ADDENDUM NO. 2

VILLAGE OF COVINGTON Wastewater Treatment Plant Improvements Phase II Blower Replacement February 19, 2019

Re: Village of Covington
Wastewater Treatment Plant Improvements Phase II – Blower Replacement

PROJ. NO: CV07112617 DWG. NO: 1D15075 SCALE: AS NOTED
DRAWN: DRM CHECKED: MJB DATE: 02/15/19 SHEET NO: 9A OF 9

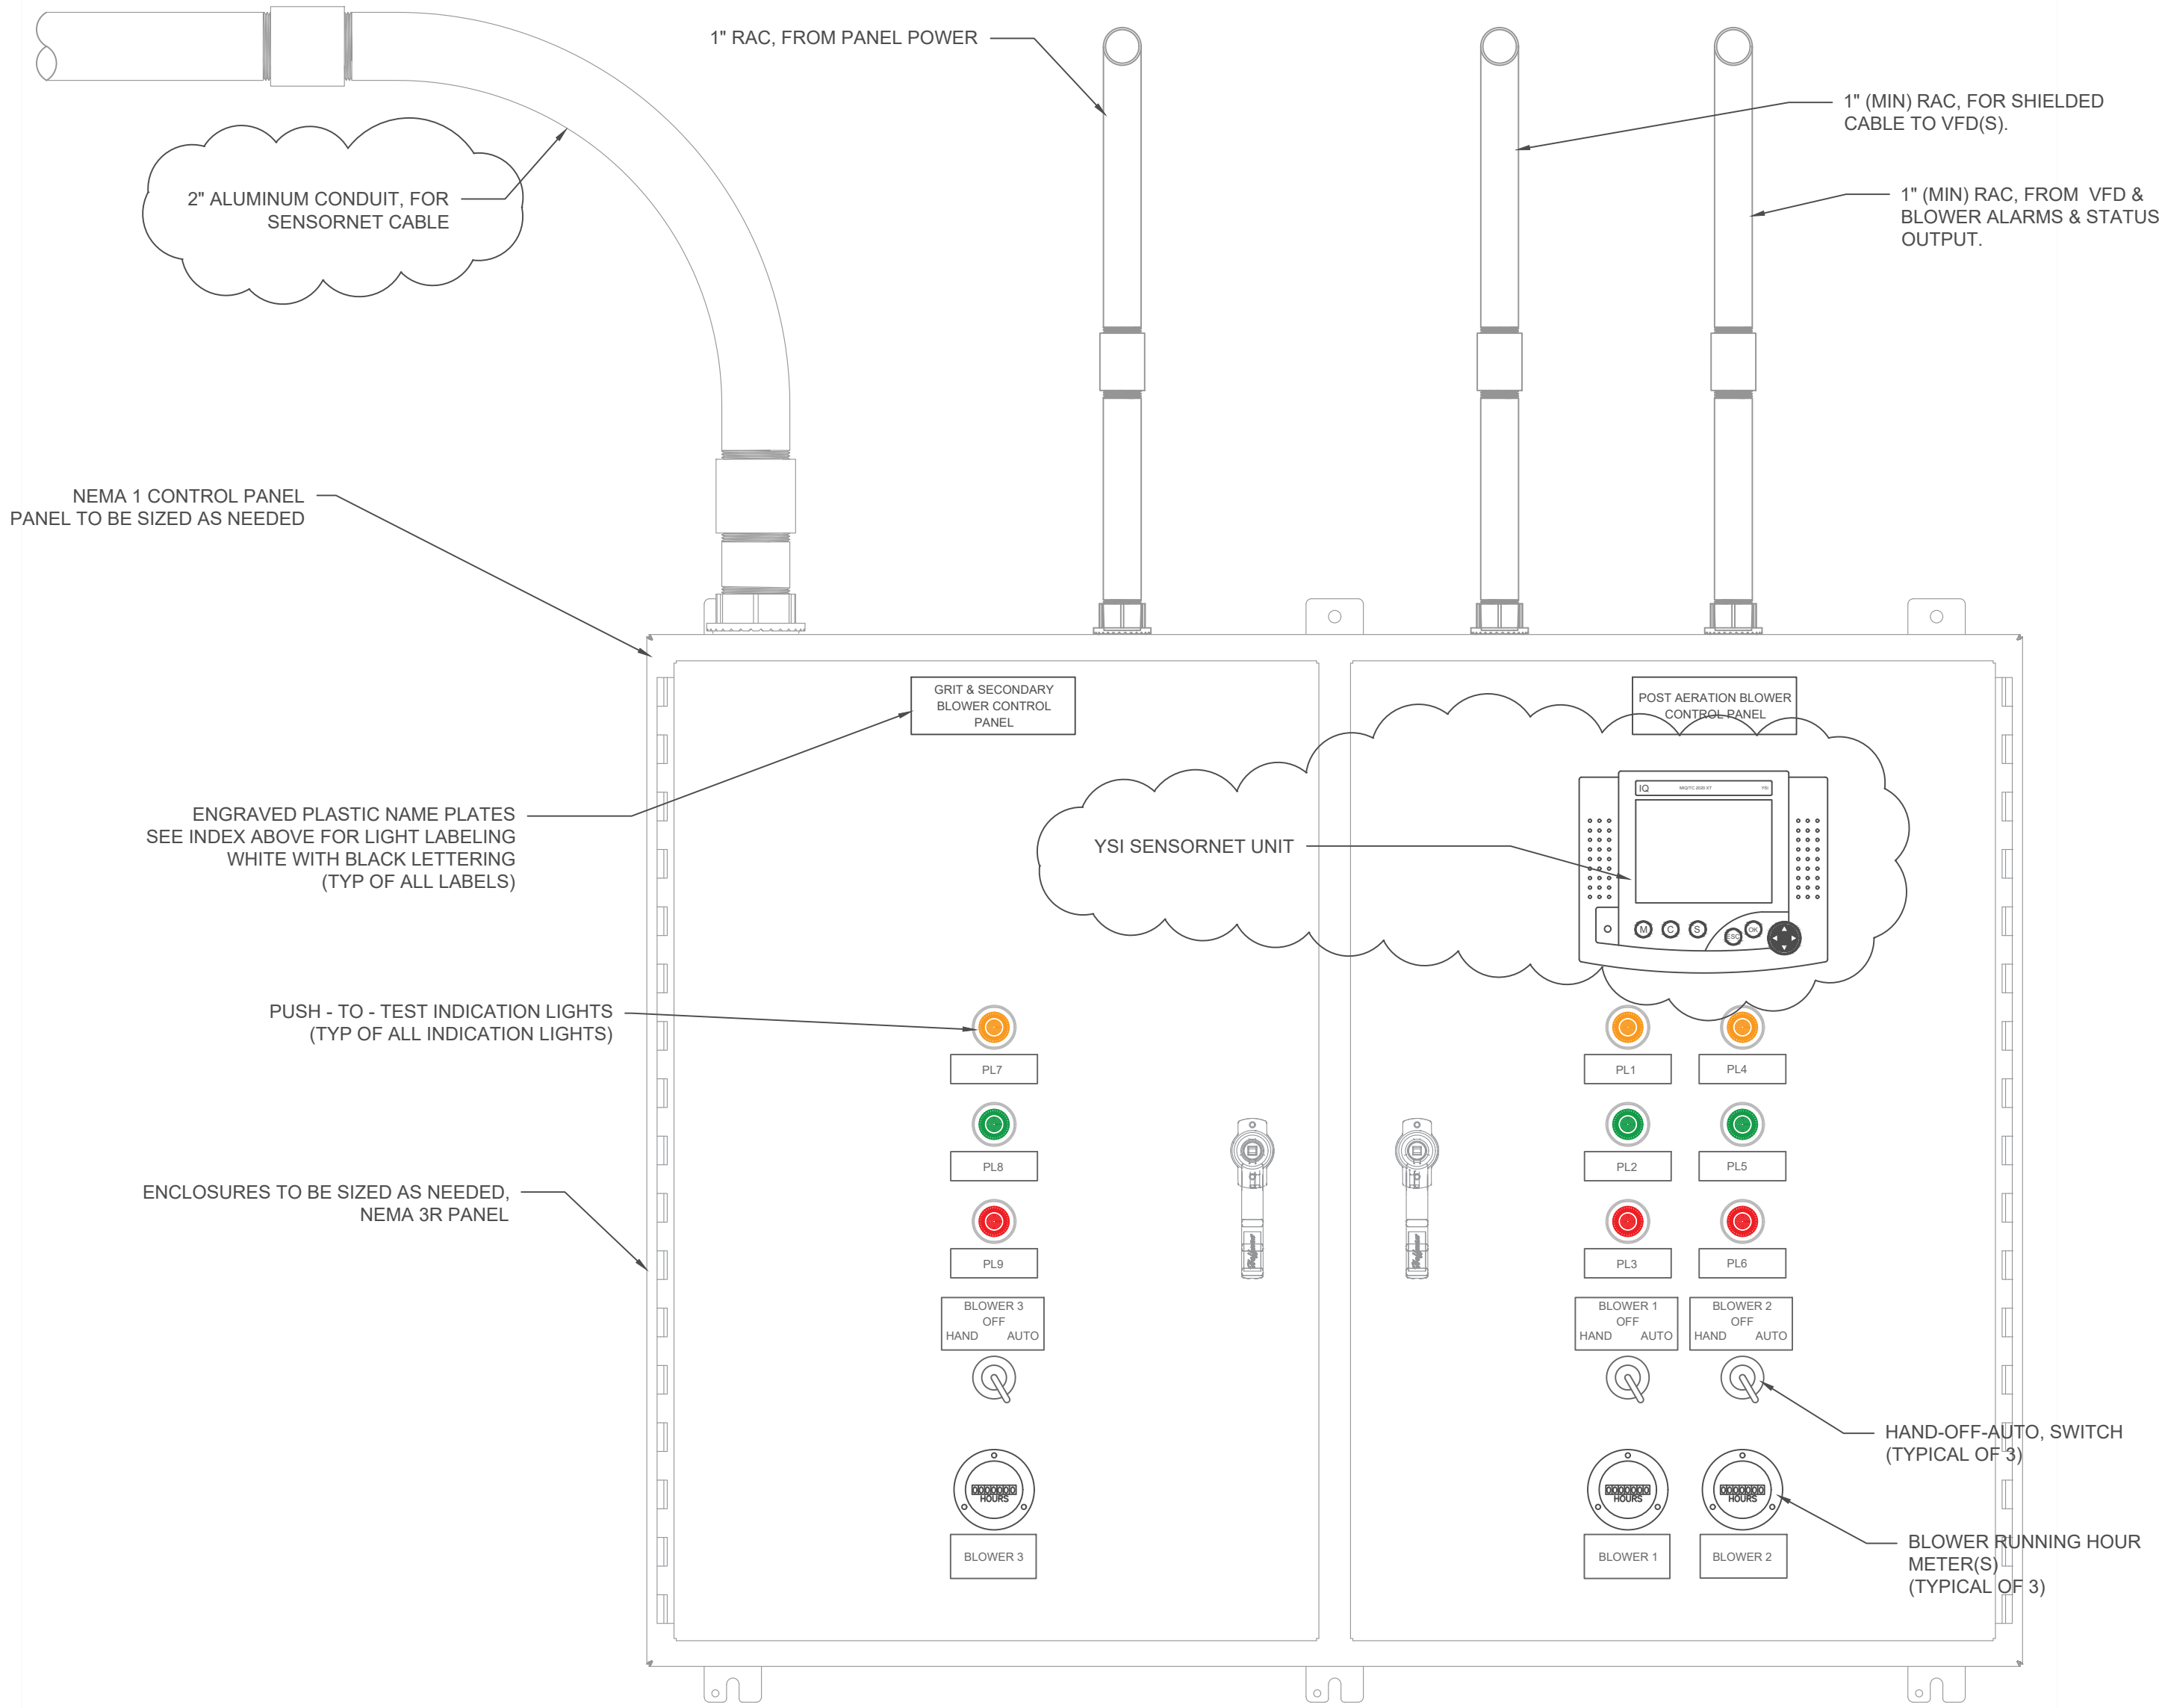
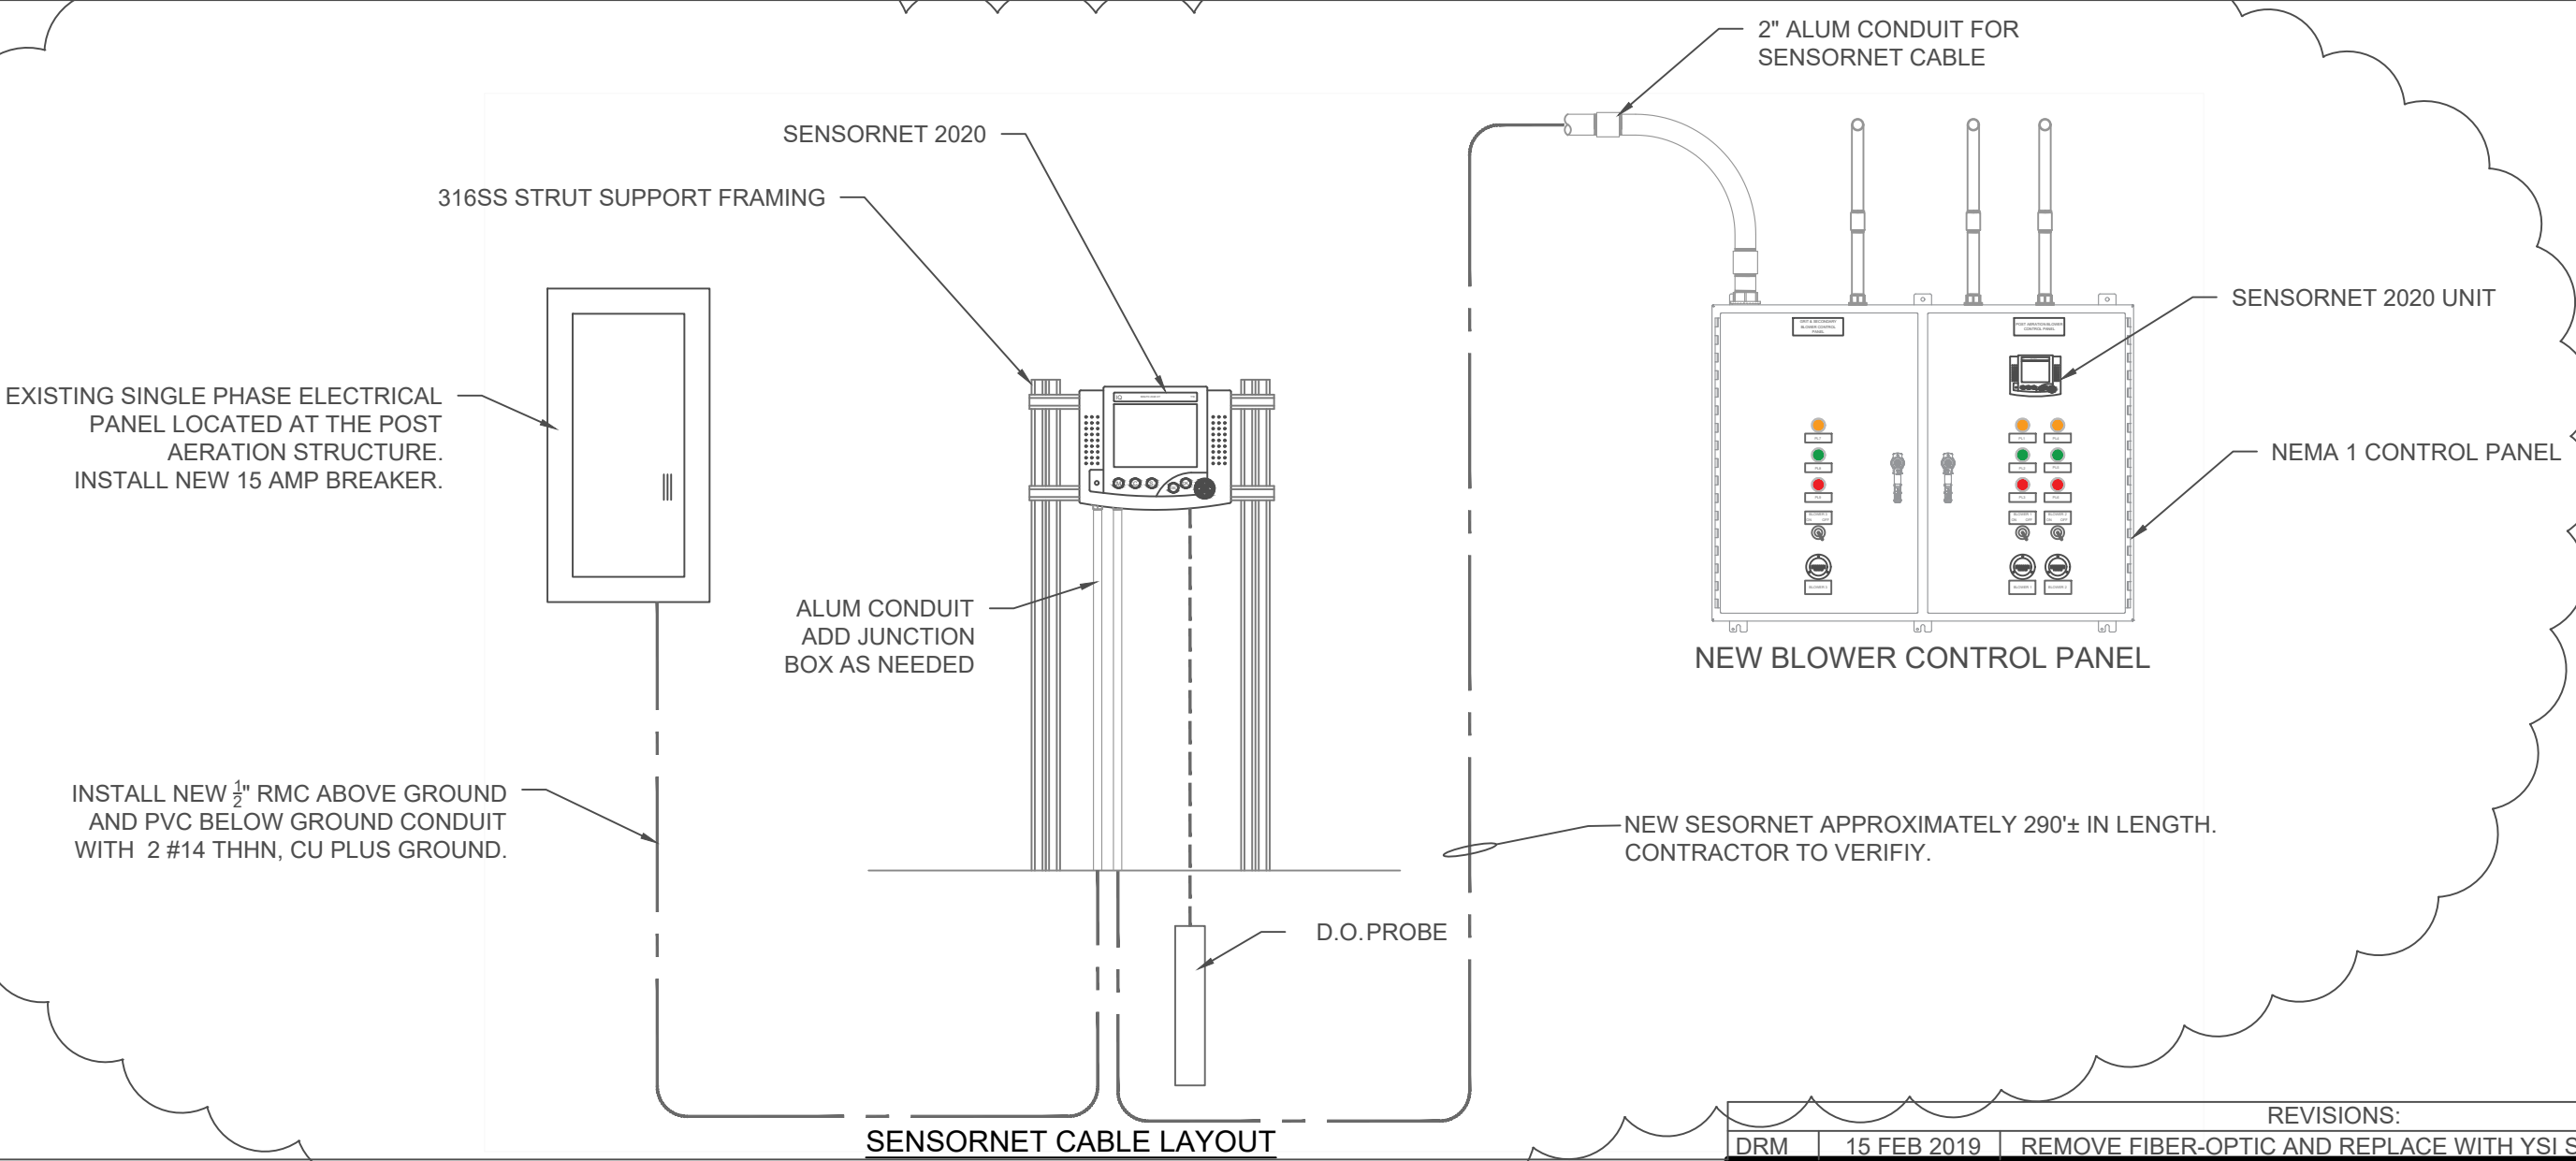
3. Sheet 2A has been updated indicated the amount of air piping to be replaced.
4. Sheets 3A, 4A, 6A, 8A and 9A indicate the changes from fiber-optic to SensorNet Cables.
5. Sheet 5A clarifies the water piping and obsolete equipment to be removed.

DRM | 15 FEB 2019 | REMOVE FIBER-OPTIC AND REPLACE WITH YSI SENSORNET
